SB-GA8-2011-68

Service Bulletin

Alternative Alternate Air Cable

All GA8-TC 320 model aircraft

Figure 3 – Console cable installation (exploded view)

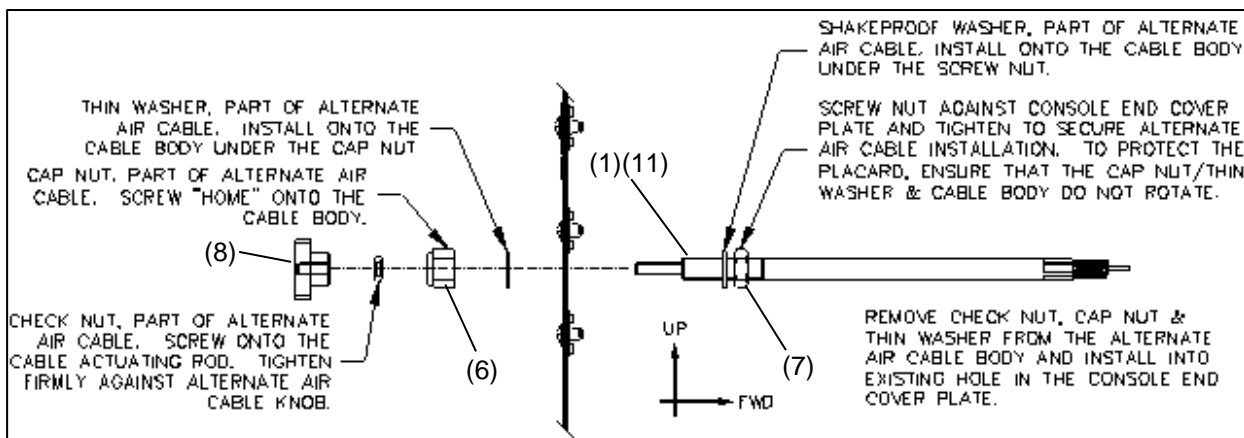
1. Loosen and remove the Nut (2) and Washer (3) and then remove the Cable (1). See Figure 6;
2. Loosen the Screw (4) and remove the Cable (1) from the PClip (5). See Figure 7;
3. Hold the Cap Nut (6) and loosen the Nut (7) from console end cover, then hold the Cable (1) and loosen the Cap Nut (6). Release the Cable Knob (8) from the Cable (1). See Figure 3;
4. Remove and discard the Alternate Air Cable P/N GA8-716013-15 (1).

1. Ream the diameter of the hole in Console Rear Cover (9) to 7/16". See Figure 9;
2. Ream the diameter of hole in the Bolt (10) to 0.080" as shown on Figure 8;
3. Take the new Alternate Air Cable P/N GA8-716013-17 (11) and install it following the instructions on Figure 3, Figure 4, Figure 5, Figure 6 and Figure 7.
